# DETAILED CONSERVATION COMMISSION AGENDA

Date: Thursday, January 27, 2022

### 1. (7:00) 152 Suffolk Rd – NOI – backyard pool, sports court, patio, and greenhouse – DEP #239-911

**5. (8:15) Hammond Pond Parkway – NOI – roadway and corridor improvement -- DEP #239-???**

NEWTON HAMMOND POND PARKWAY			
STATE	FED AID PROJ NO	SHEET NO	TOTAL SHEETS
MA	N/A	10	30
PROJECT FILE NO. -			
CONSTRUCTION PLAN 4 NOTICE OF INTENT PLAN SET

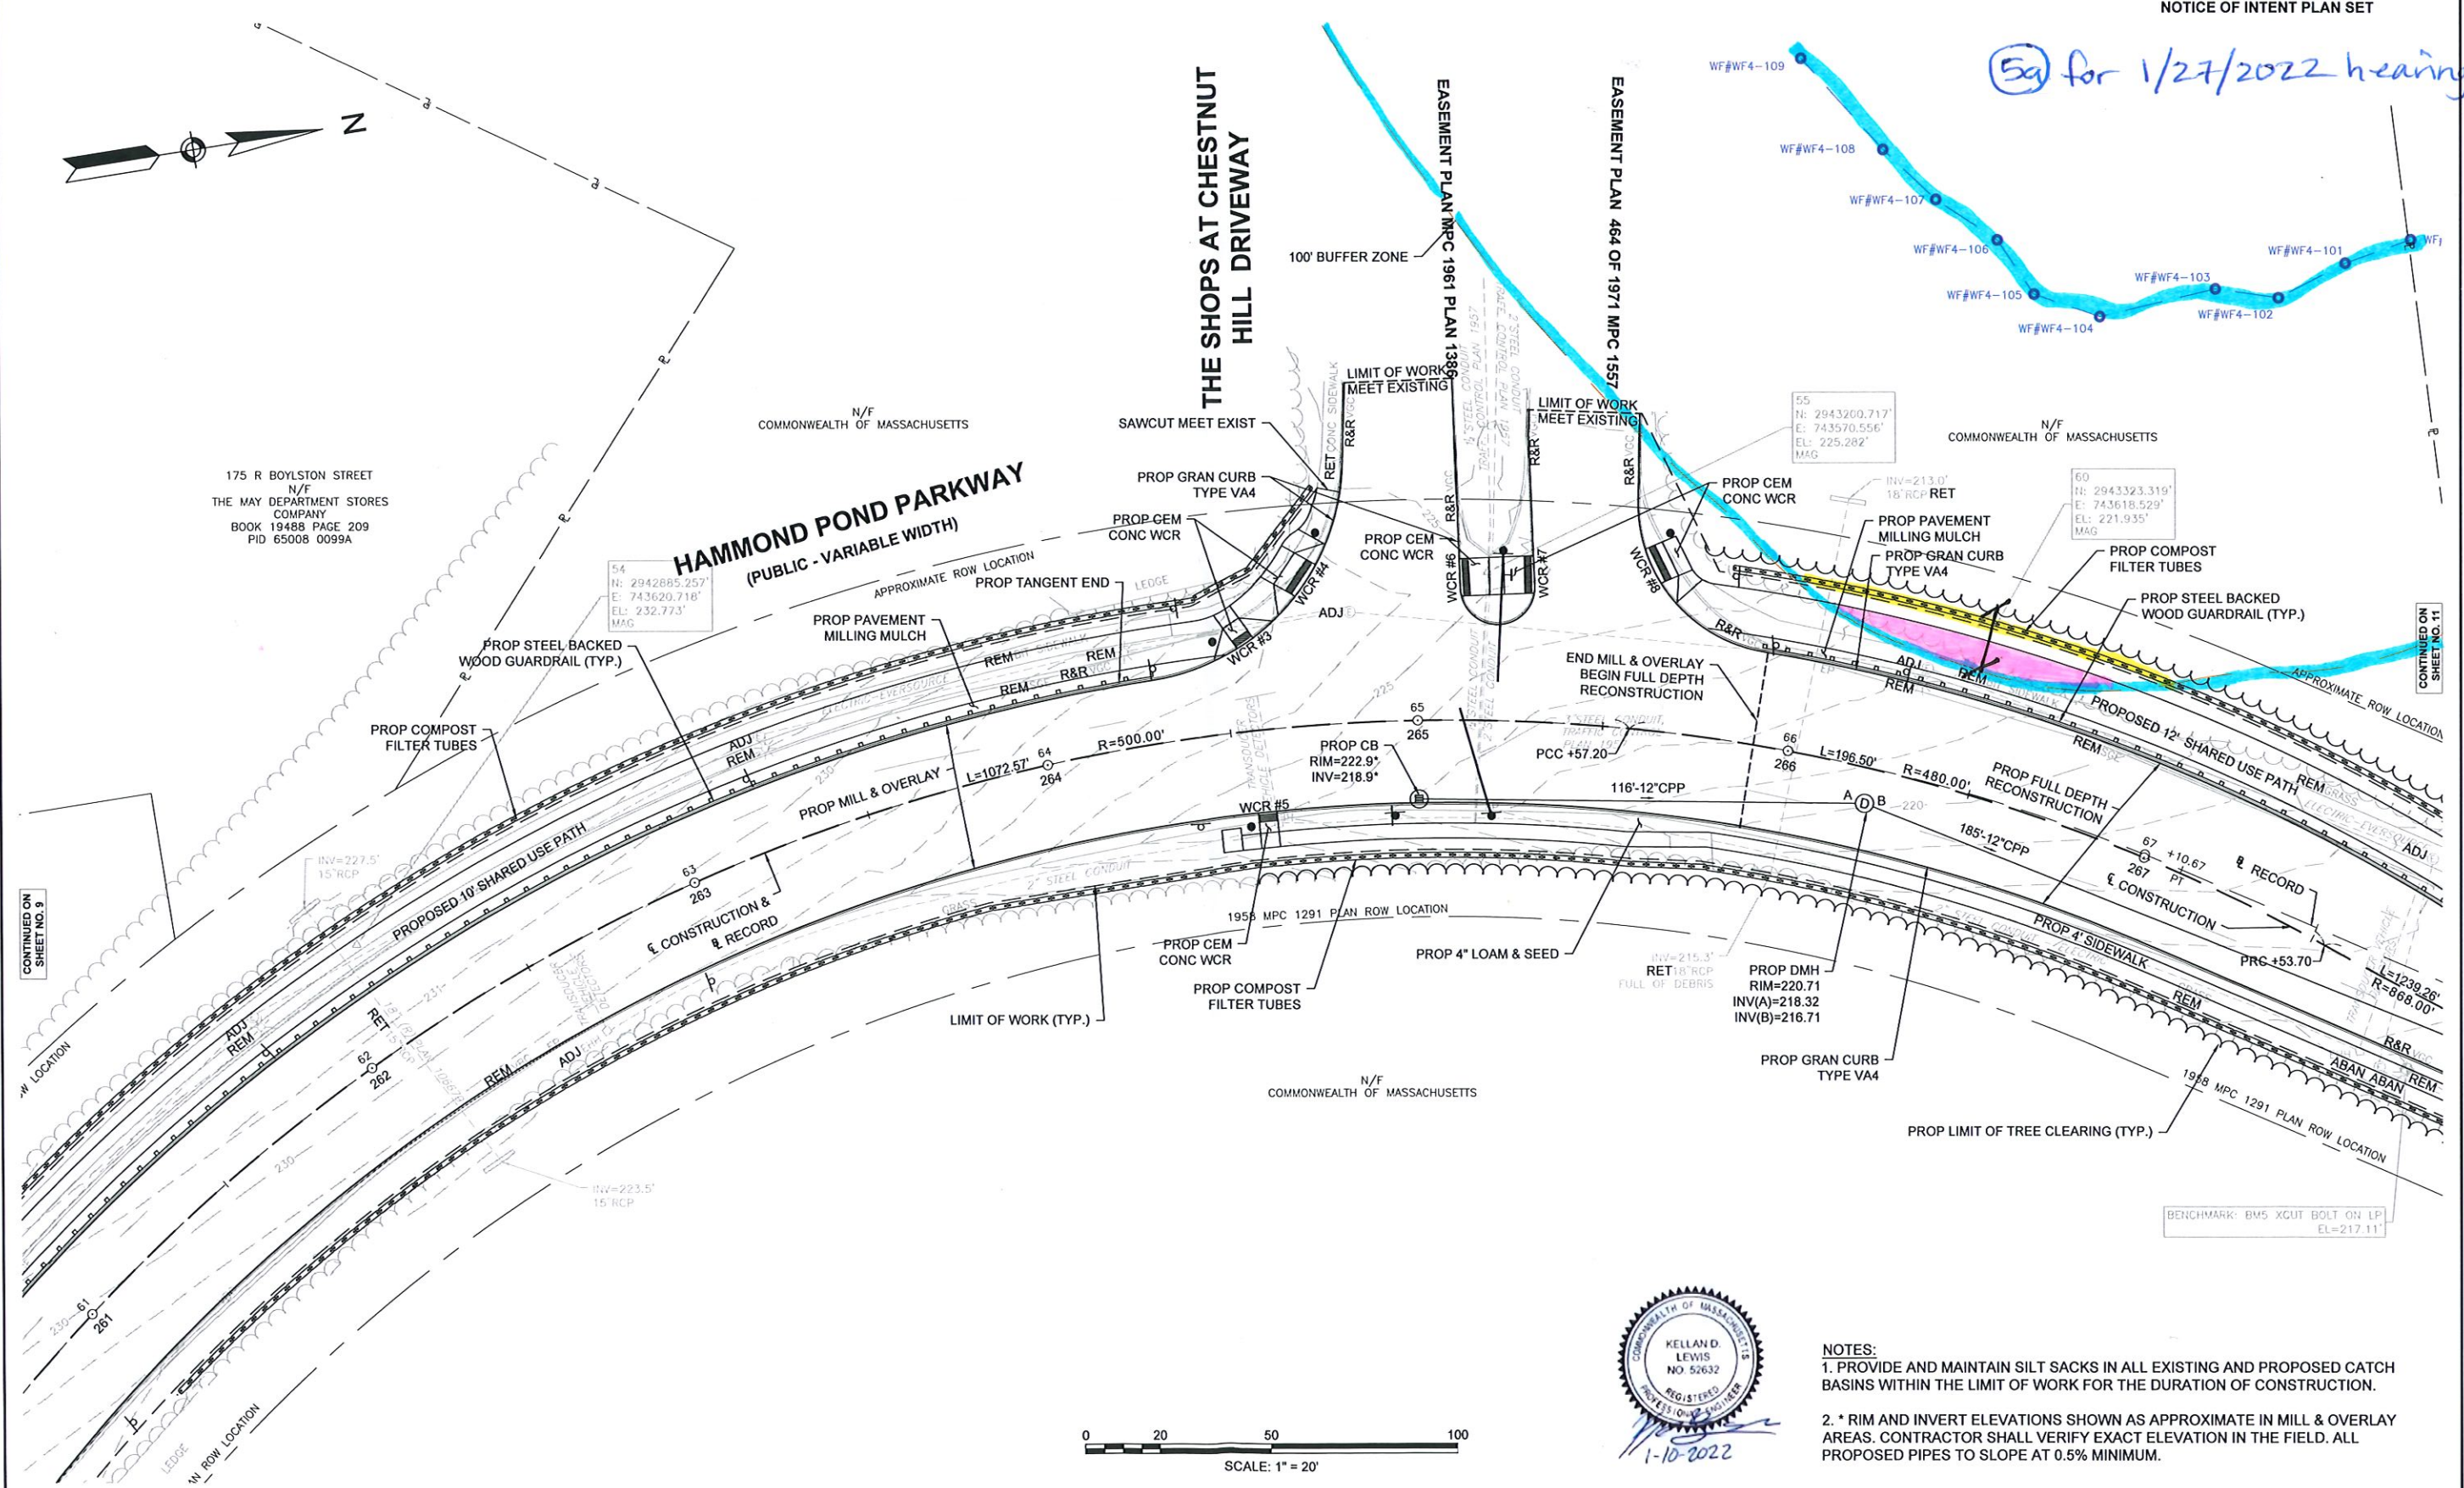
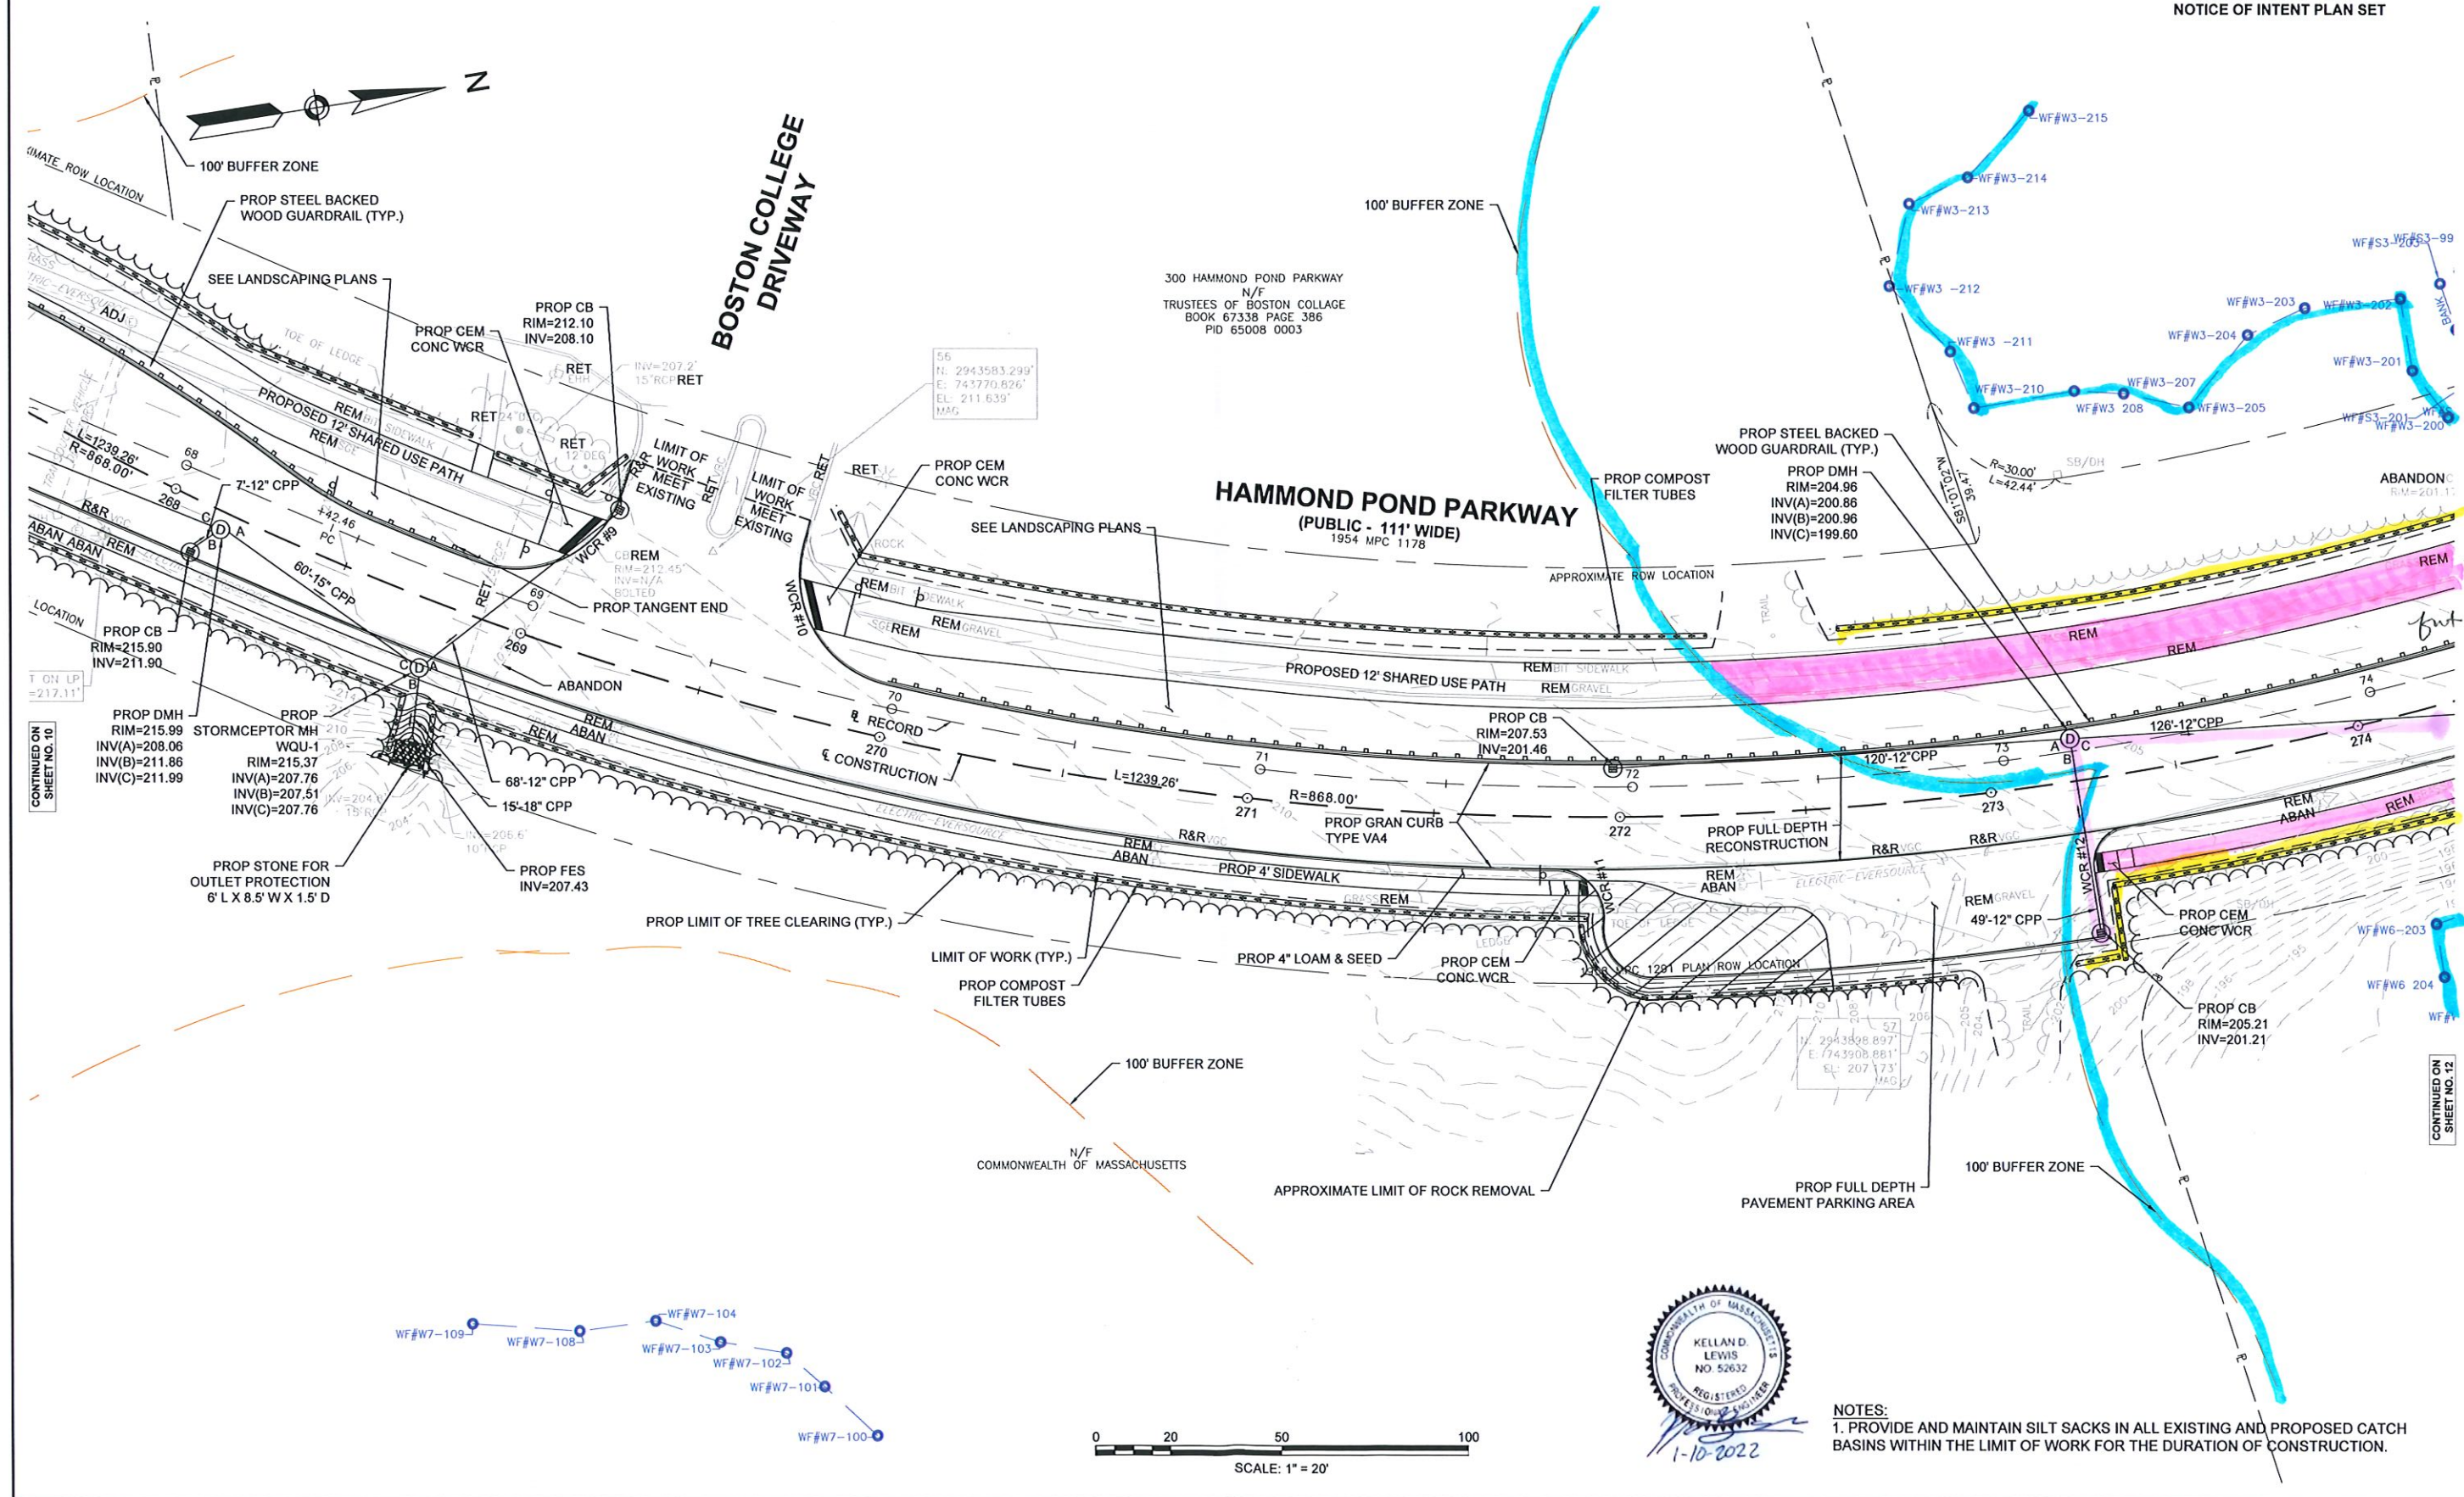
- Staff sought and received revised plans with improved legibility.
- The majority of the alterations within jurisdictional wetland areas are within degraded and disturbed areas (i.e., within the existing roadway and grass/dirt shoulder – “inboard of the existing guardrail”). Overall “paved” area will be reduced.

- The plans provided are very “conceptual” and identified as “not for construction”. More detail may be necessary
- Questions:

- If areas clearing (and grading?) along the edge of the tree line are required to construct the shared use path, those areas should be clearly identified on the plans.

- There will be significant grading at the northeast corner of the new parking area, yet no new grade lines are shown and it appears that insufficient space is provided for side slopes. How will this area be addressed?
- On Landscape Plan sheet 5 there is a “limit of grading” label that appears to be on the property line. It should be removed.
- There is no erosion control/limit of work shown that would protect the “island of trees” near Hammond Brook. That should be added.
- Will there be any invasive control efforts?

- Stockpiling areas should be identified on the plans.

- Compost sock will not provide sufficient erosion controls around the new stormwater discharge points (excavation in steep slopes) and the parking lot construction area (where significant fill is being brought in on an existing steep slope). Erosion control must be entrenched silt fence and staked compost sock.
- Will the road remain open during construction?
- When the old stormwater system is abandoned, will there be any disturbance outside the street layout?
- Will there always be a functioning stormwater collection and distribution system?

- There aren't details of the stormwater discharge points, but the plans indicate riprap aprons 5' L X 7.1' W X 1.5' D. How will the riprap be retained on steep slopes?

- Staff Recommendation: Once all questions are answered and concerns addressed and whenever the Commission feels that the plans are adequate for the Commission's purposes, vote to close the hearing and issue an OOC with the following special conditions:

- Stockpiling shall ...
  - Outfall details must ...
  - An invasives control plan shall ...
